**SUBDIVISION COMMITTEE
METROPOLITAN AREA PLANNING COMMISSION**

**STAFF REPORT
(Final Plat)**

CASE NUMBER: S/D 93-58 GARCIA ADDITION

LOCATION: East of 135th Street West and north of 13th Street North

VICINITY MAP:

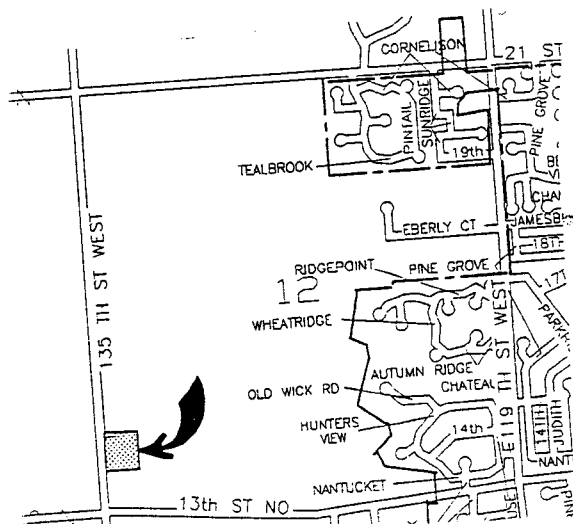
Note: This site is in the County and is expected to use on-site sewer and water facilities. However, this plat is just over 4.6 Acres and while 5 Acres is typically required for use of a sanitary lagoon system, under certain circumstances, a lot as small as 4.5 acres can be allowed.
